STATE OF NORTH CAROLINA
DEPARTMENT OF TRANSPORTATION

Subject: **Request to modify Section 404 permit, 401 WQC, and Neuse Buffer Certification.** TIP R-2539. NC 55 Widening From US 17 in Bridgeton to NC 304 in Bayboro, Craven and Pamlico Counties. State Project No. 8.1170901. Federal Aid Project STP-55(1). USACE Action ID 199303531. DWQ Project No. 021232, WQC No. 3415. DCM CAMA Permit No. 55-03. $200 debit from WBS Element 34452.1.1.

Subject: **Application for Division of Coastal Management Modification of the Major Development Permit No. 55-03 for TIP No. R-2539.** NC 55 Widening From US 17 in Bridgeton to NC 304 in Bayboro, Craven and Pamlico Counties, NCDOT Division No. 2. Federal Aid Project STP-55(1). State Project No. 8.1170901. WBS Element No. 34452.1.1. USACE Action ID 199303531. DWQ Project No. 021232, WQC No. 3415.

SITE 1 -L- STA. 56+30 TO 56+55 LT

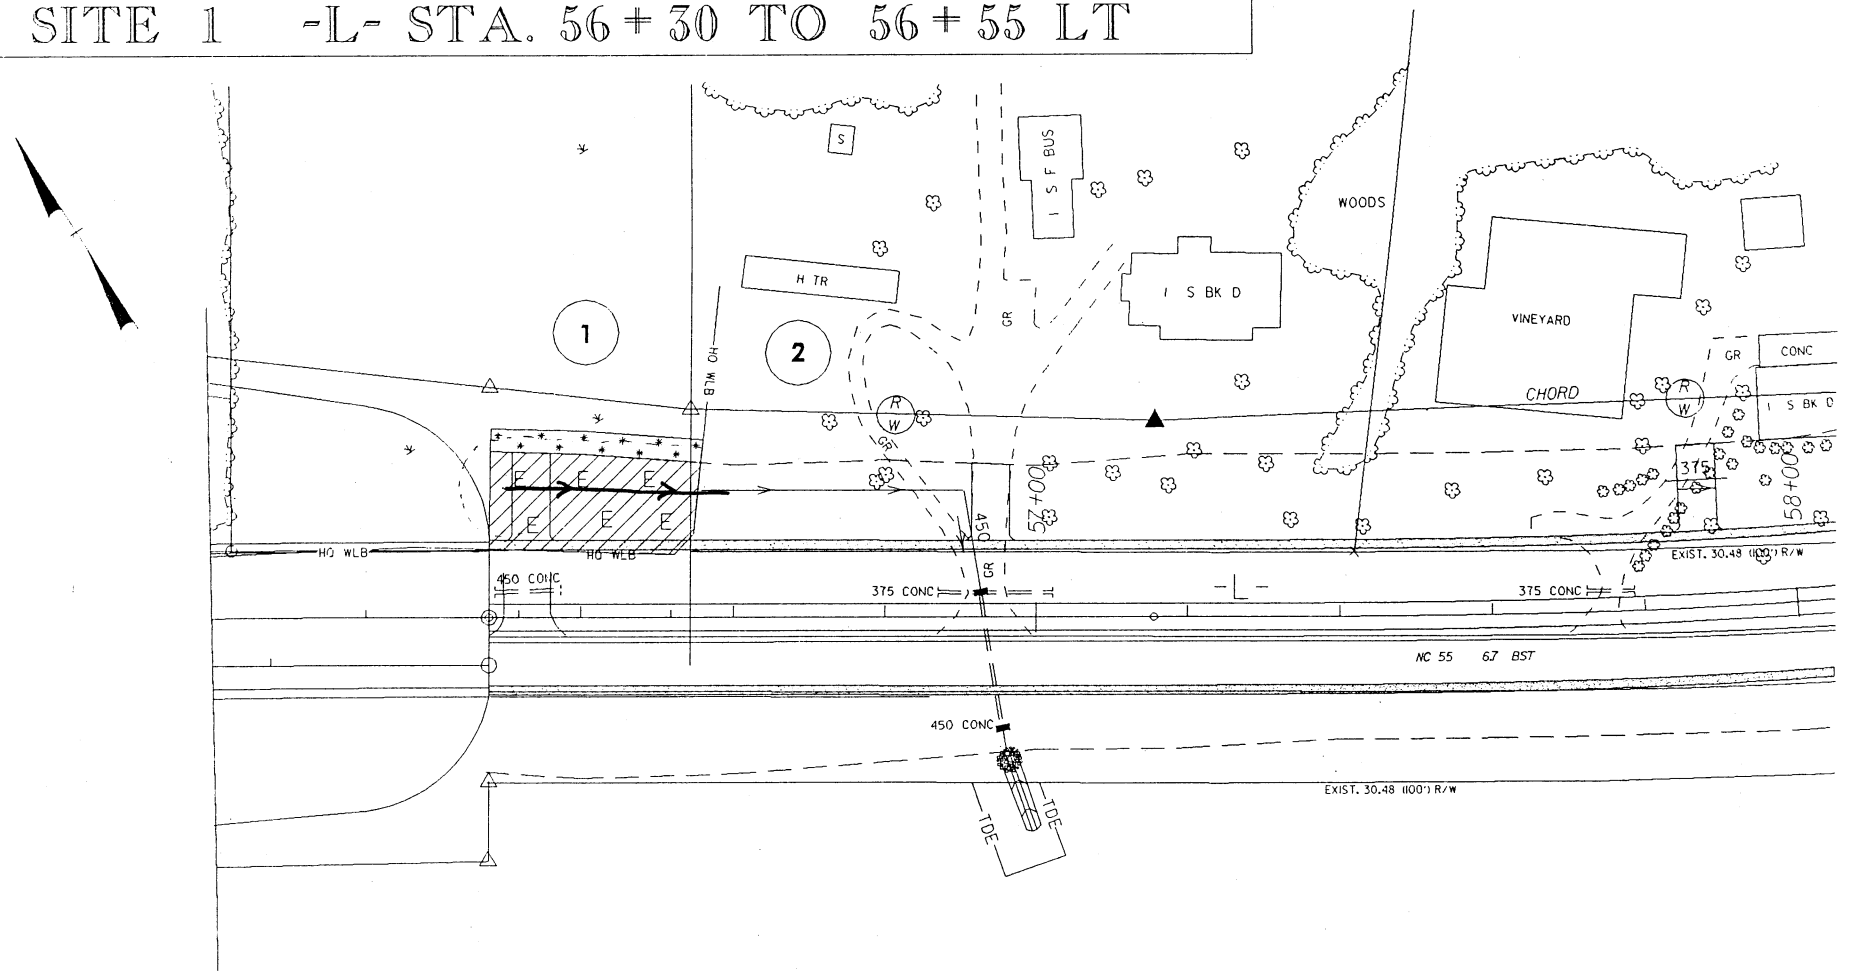
Site 1, Permit Sheet 7 of 40
Station 56+30 left
Because of the low grade and minimal drainage potential of the natural ground elevation at this site, it will be necessary to install a typical V-ditch with 6:1 side slopes to drain the subgrade of the new road. Based on the Boussinesq equation calculations, there will be additional impacts resulting from the drainage impact from this ditch. The Ditch Impact Study, dated July 2003, is attached.
Impact change: increase of 0.06 acres of non-riverine wetland impacts

Site 1, Permit Sheet 7 of 40
Station 56+30 left
Because of the low grade and minimal drainage potential of the natural ground elevation at this site, it will be necessary to install a typical V-ditch with 6:1 side slopes to drain the subgrade of the new road. Based on the Boussinesq equation calculations, there will be additional impacts resulting from the drainage impact from this ditch. The Ditch Impact Study, dated July 2003, is attached.
Impact change: increase of 0.06 acres of non-riverine wetland impacts

SITE 2 -L- STA. 59+70 TO 61+00 LT

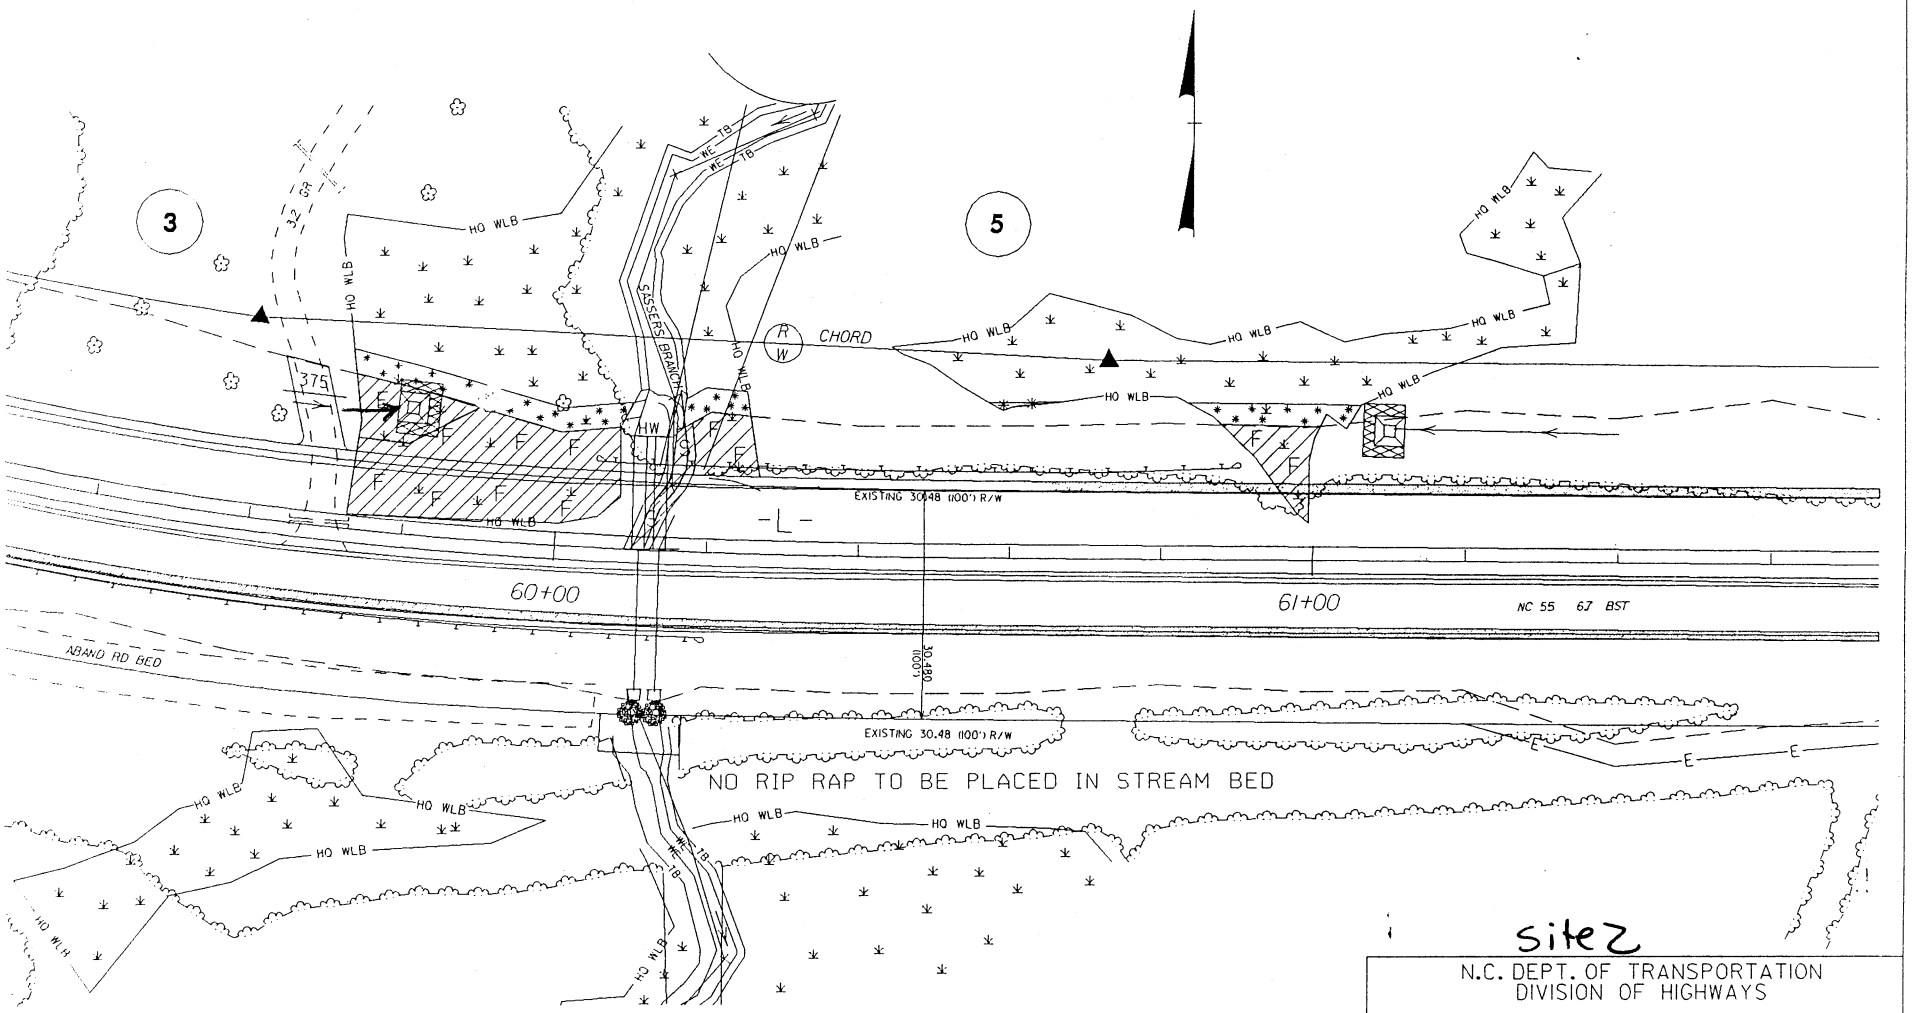
Site 2, Permit sheet 8 of 40
Station 59+80 left
Drainage effects from the wetland ditch feeding into the pre-formed scour hole were not calculated because this ditch will bring water into the wetland, contributing to the hydrology rather than diminishing it.
Impact change: no change to jurisdictional impacts

Site 2, Permit sheet 8 of 40
Station 59+80 left
Drainage effects from the wetland ditch feeding into the pre-formed scour hole were not calculated because this ditch will bring water into the wetland, contributing to the hydrology rather than diminishing it.
Impact change: no change to jurisdictional impacts

SITE 4 -L- STA. 74+85 TO 77+40 RT & LT

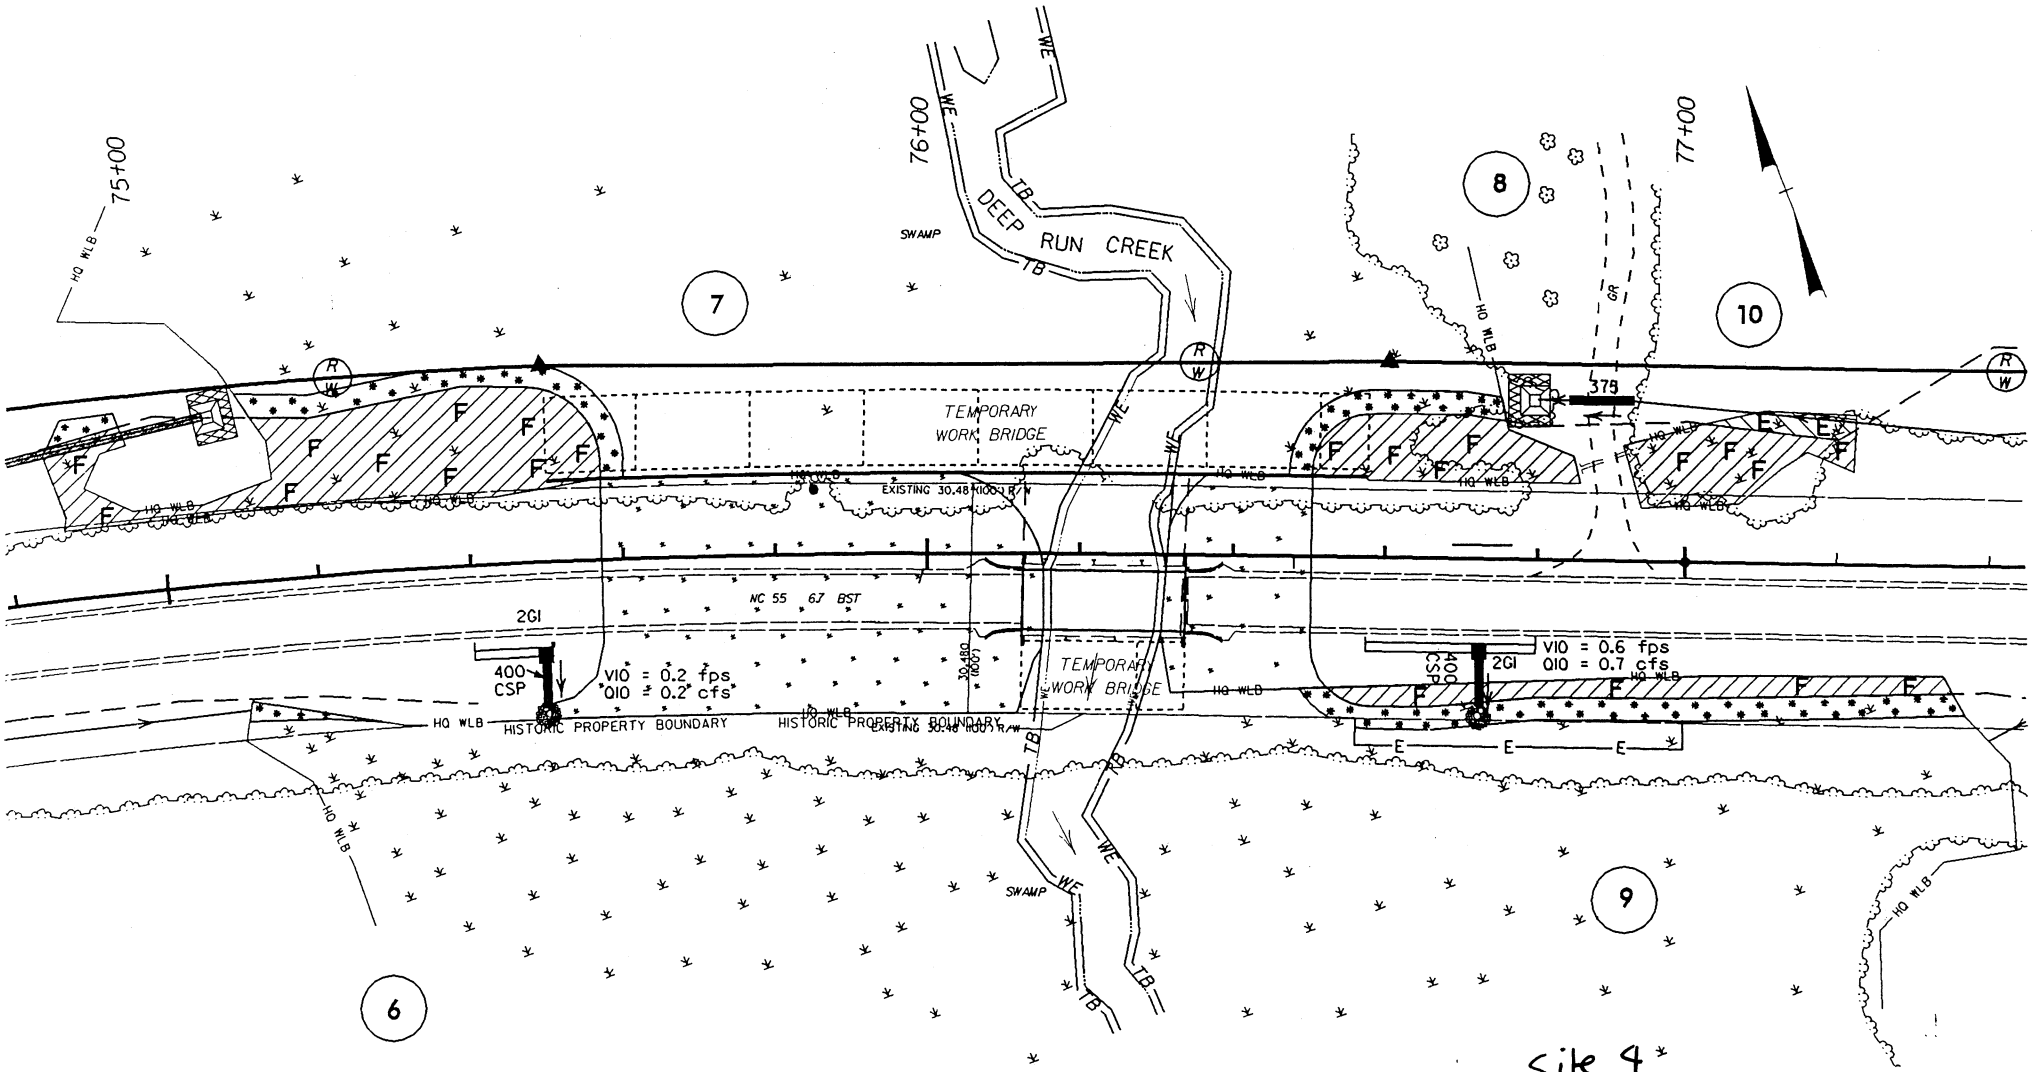
Site 4, Permit sheet 10 of 40
Station 77 +00 to 77+20, left
At this site an area of mechanized clearing in wetlands has been changed to excavation to accommodate a drainage swale.
Impact change: no change to jurisdictional impacts

Site 4, Permit sheet 10 of 40
Station 77 +00 to 77+20, left
At this site an area of mechanized clearing in wetlands has been changed to excavation to accommodate a drainage swale.
Impact change: no change to jurisdictional impacts
